ADDENDUM

PROJECT: Cherokee Regional Medical Center
Emergency Department Addition
& Surgery / CS Remodel
Cherokee, Iowa

AD-2

DATE ISSUED: Wednesday, April 11, 2012

Drawing Title Storage Tank Detail	
From Sheet: M-100	for CA use:
Drawing # M-100.2

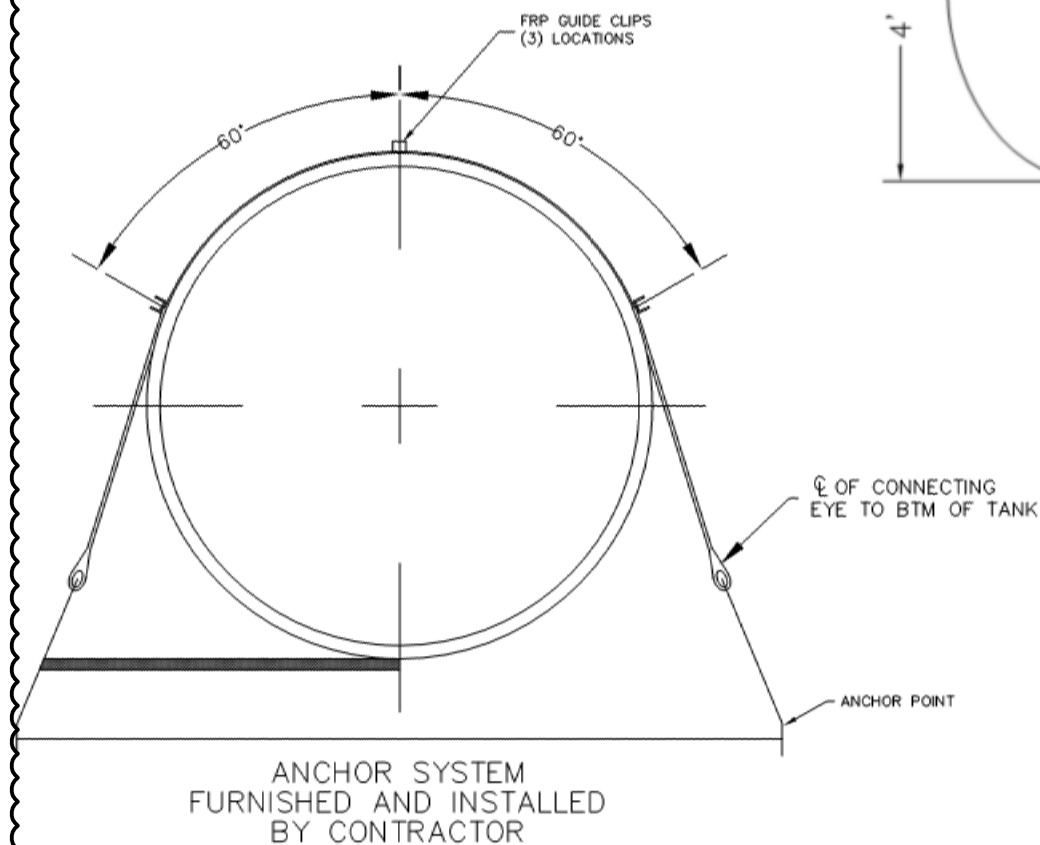
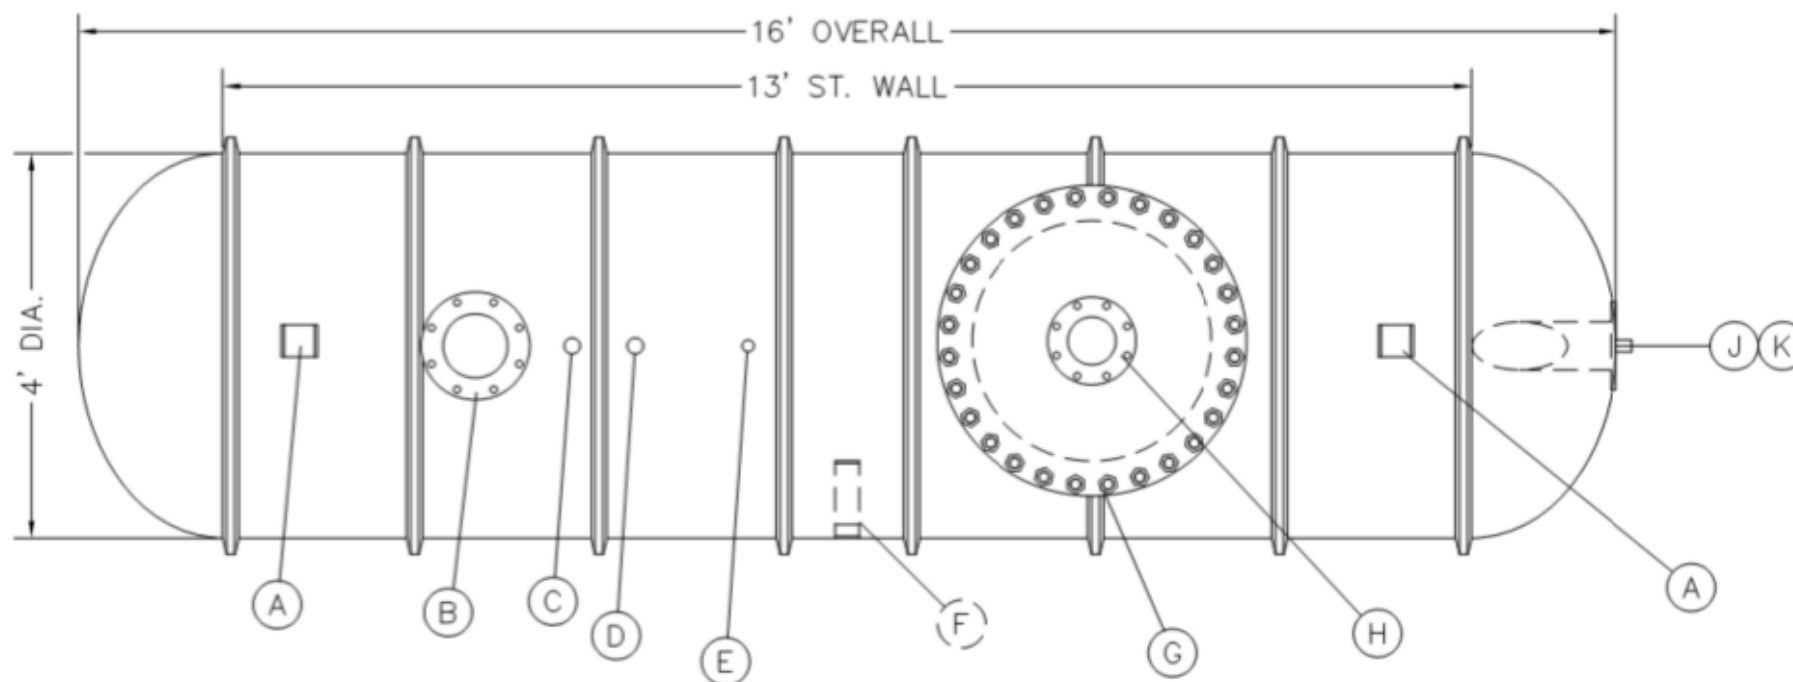
In reference to drawing Sheet M-100 - Basement Mechanical Demolition and New Work Plans, see attached Supplemental Drawings M-100.1 and M-100.2.

From Sheet:	M-101	for CA use:
Drawing #	M-101.2

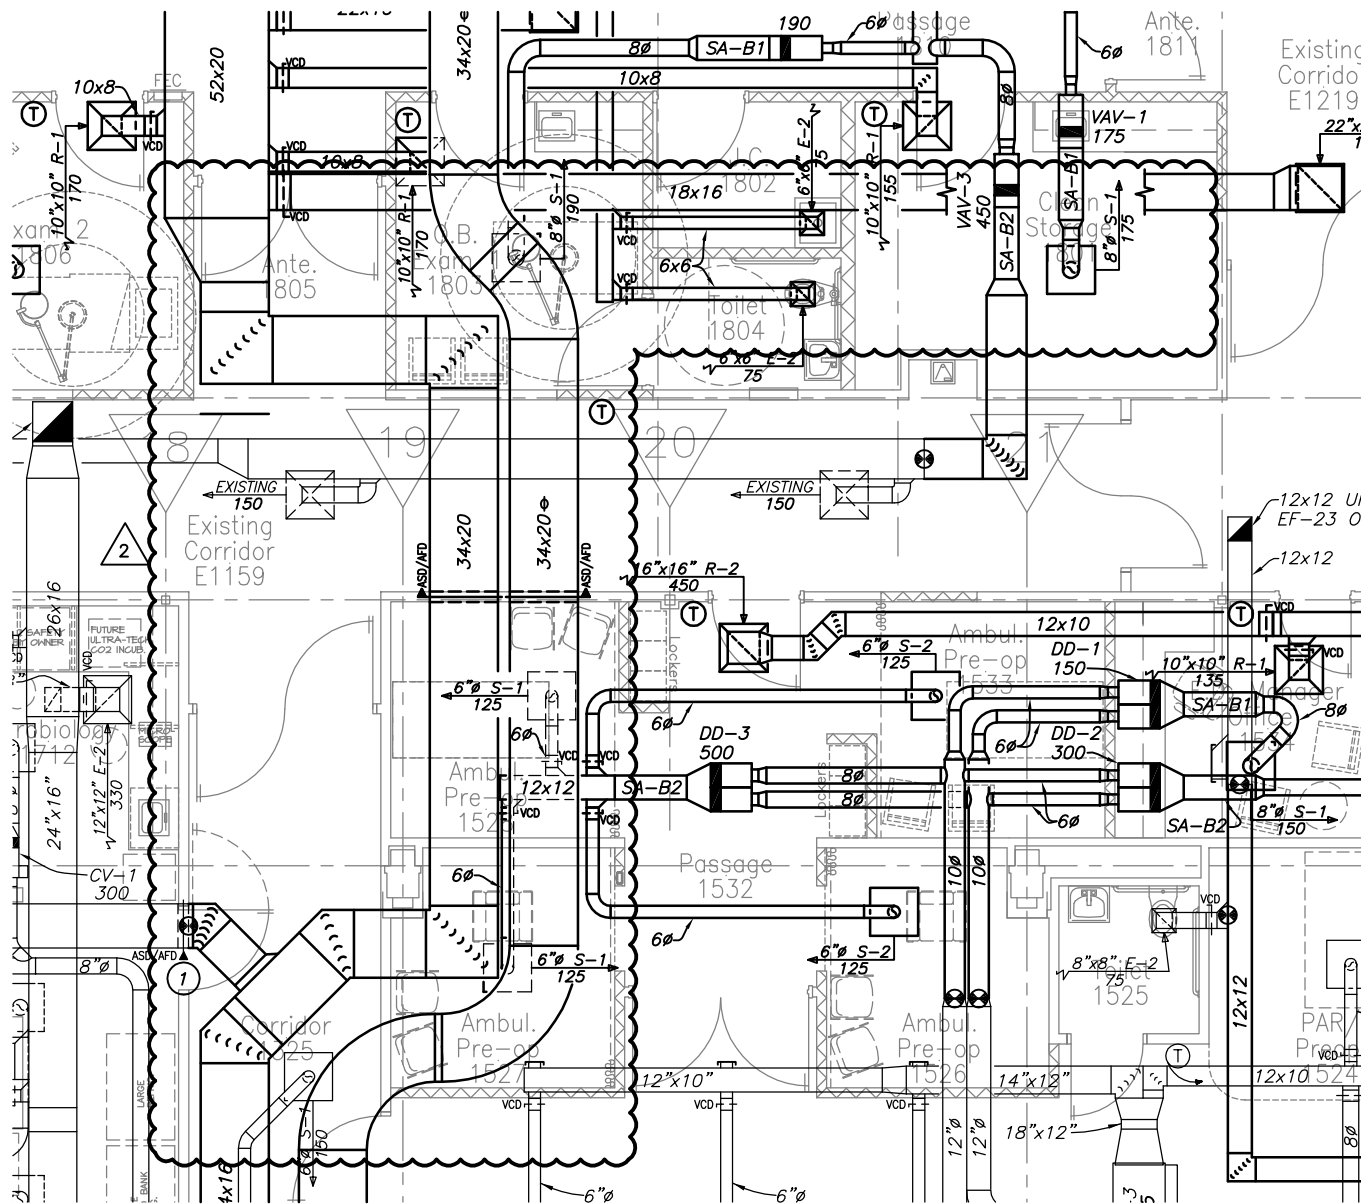
In reference to drawing Sheet M-101 - First Floor HVAC Plan, see attached Supplemental Drawing M-101.2.

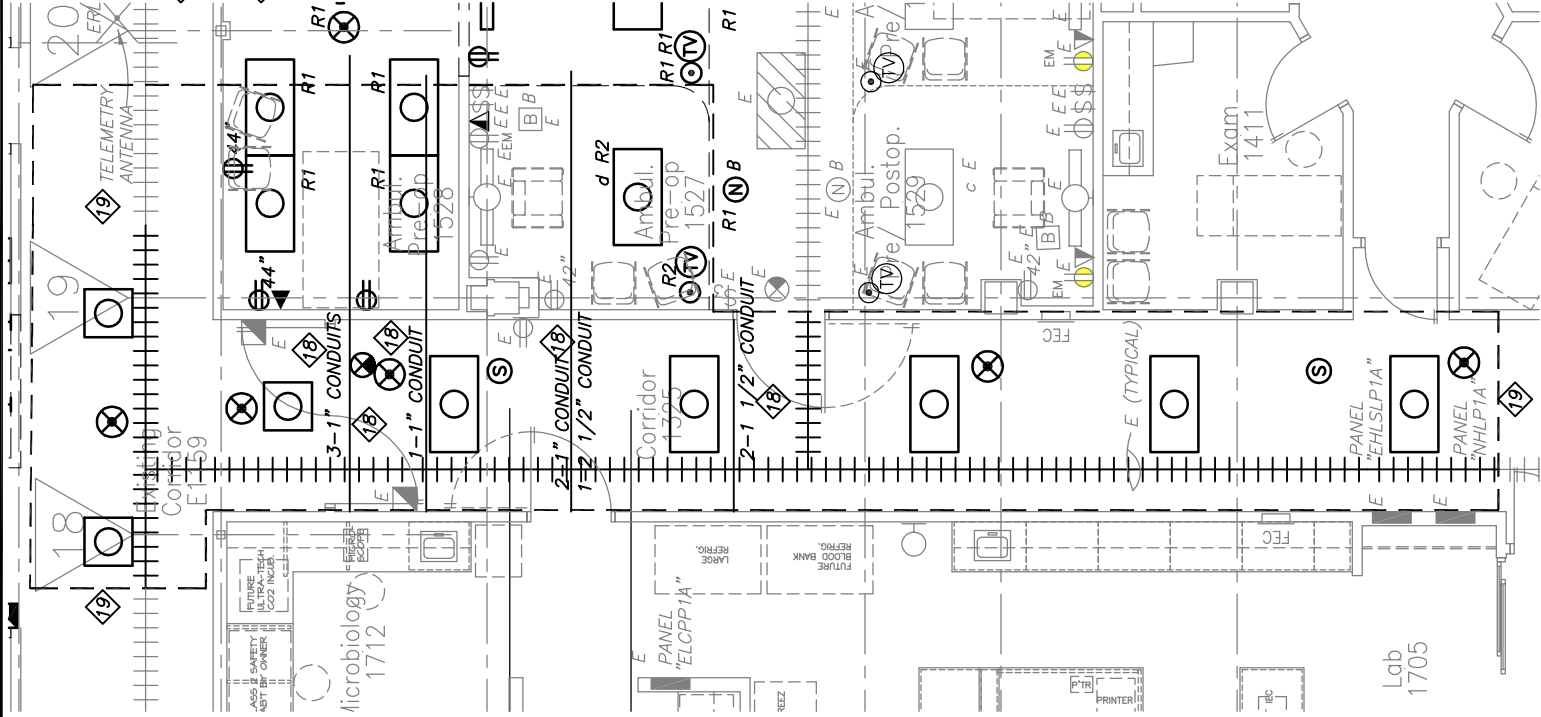
In reference to drawing Sheet E-102 – North First Floor Electrical Demolition Plan, see attached Supplemental Drawing E-102.2

18 COORDINATE WITH GENERAL AND MECHANICAL CONTRACTOR TO RELOCATE CONDUIT AND WIRE UP OR DOWN AS NEEDED FOR INSTALLATION OF NEW DUCT WORK IN AREA AS HIGHLIGHTED.

19 COORDINATE WITH GENERAL AND MECHANICAL CONTRACTOR TO SUSPEND OR REMOVE AND REINSTALL AS NEEDED ALL ELECTRICAL CEILING DEVICES IN CORRIDOR AND ROOM AREA AS SHOWN. ADJUST LOW VOLTAGE CABLE HOOKS AND WIRE AS NEEDED FOR INSTALLATION OF NEW DUCT WORK IN AREA AS HIGHLIGHTED.

Drawing #
E-104.4

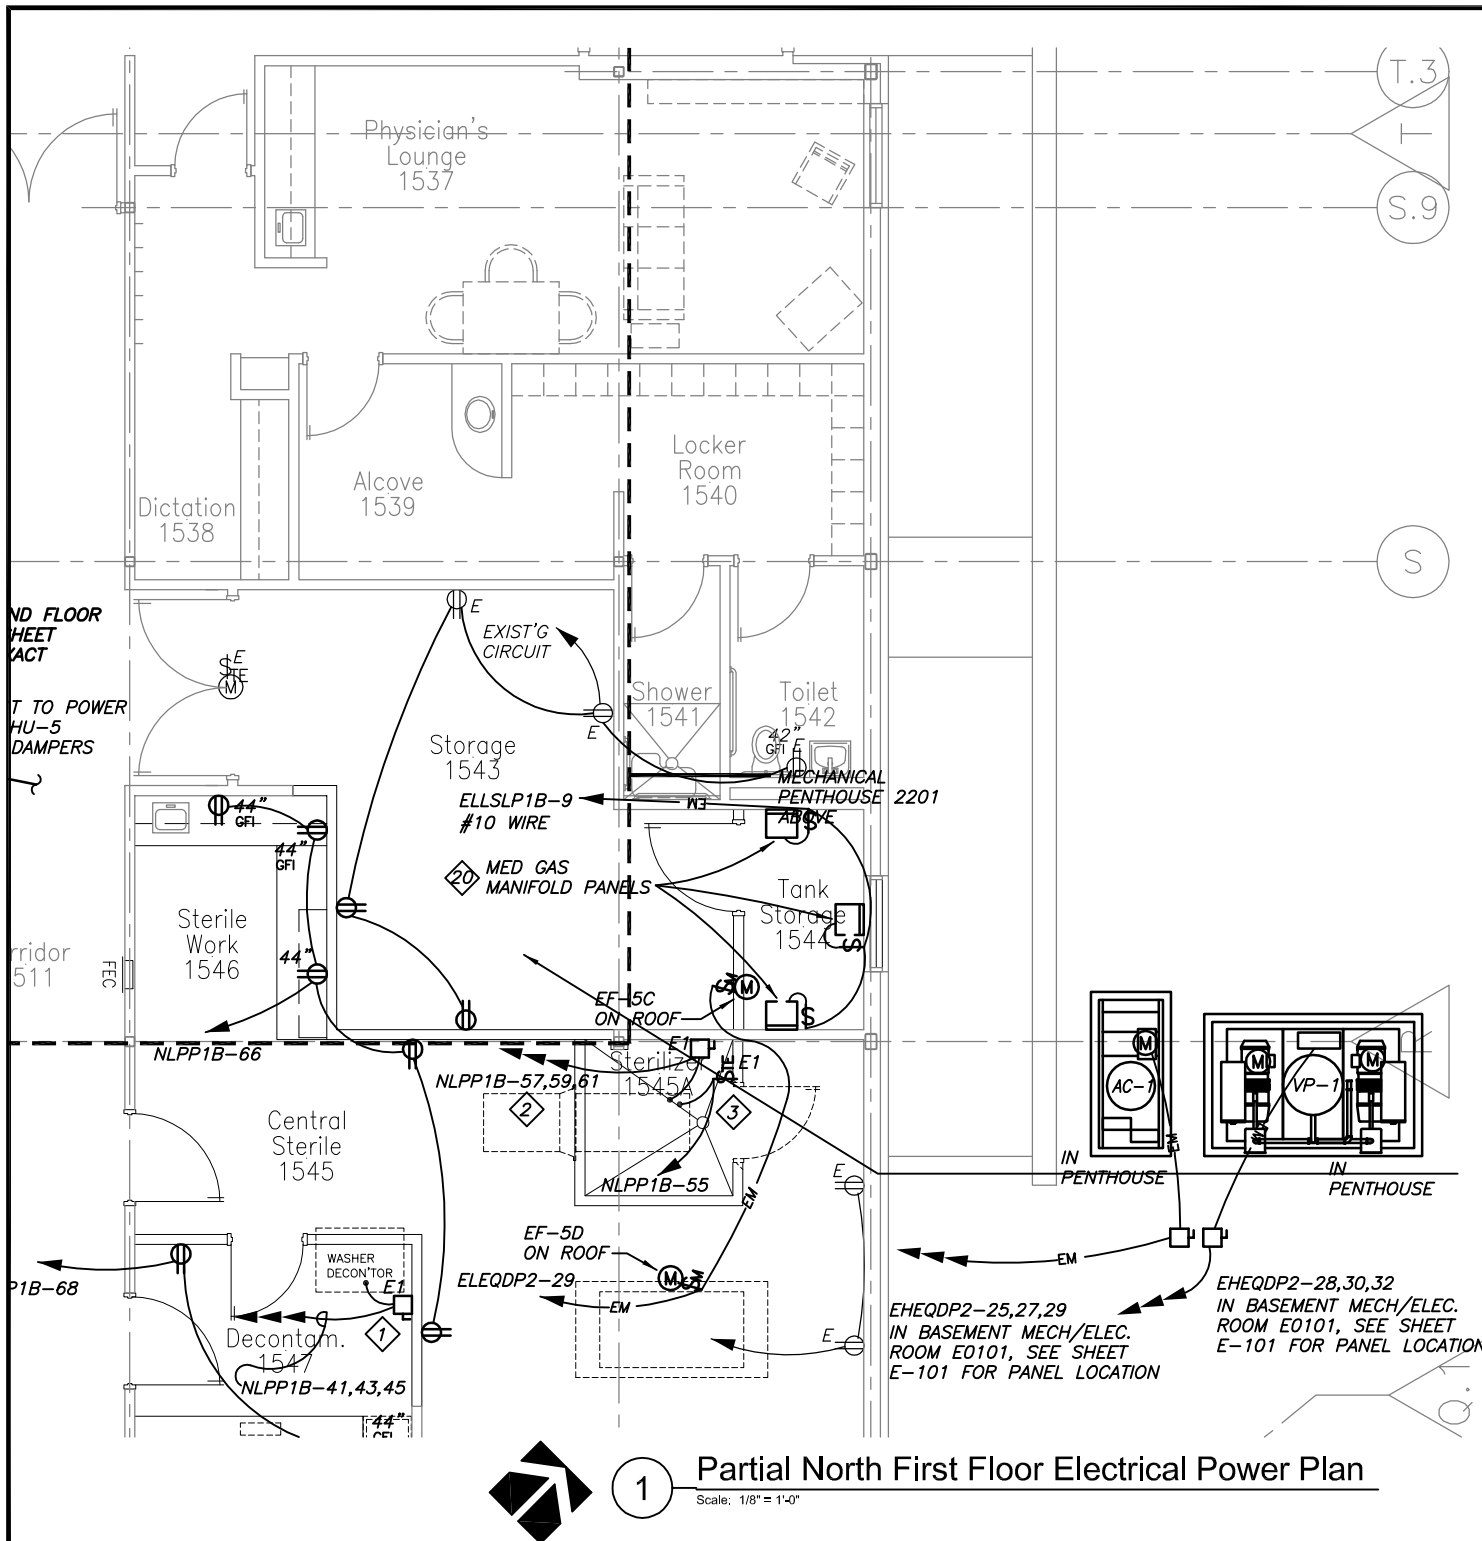
In reference to drawing Sheet E-104 – North First Floor Electrical Power Plan, see attached Supplemental Drawings E-104.2, E-104.3, E-104.4.
